**CERTIFICATE OF APPROPRIATENESS**

**Property:** 712 Arlington Street, lot 15, block 257, Houston Heights Subdivision. The property includes a historic 1,346 square foot, one-story wood frame single-family residence and a detached shed situated on a 6,600 square foot (50' x 132') interior lot.

**Proposal:** Alteration – Construct a 1,234 square foot two story addition and attached garage at the rear of the contributing residence. The addition will be one story beginning at the existing rear wall, and the two story portion will begin 18'-6" further back. The two story portion will feature a 19'-11" eave height and 27'-3" ridge height.

WEST ELEVATION – FRONT FACING ARLINGTON STREET

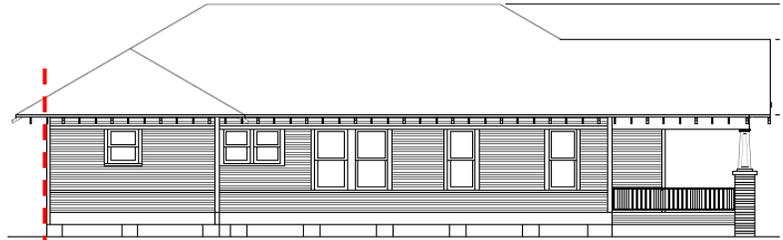
I **SUPPORT A PARTIAL APPROVAL** of this Certificate of Appropriateness. The window and partial pediment proposed in the west elevation addition is not necessary and distracts from the existing historical character of the existing structure. A continuous hip roof is in character with the remainder of the existing structure and would allow the visual importance of the existing structure to remain.
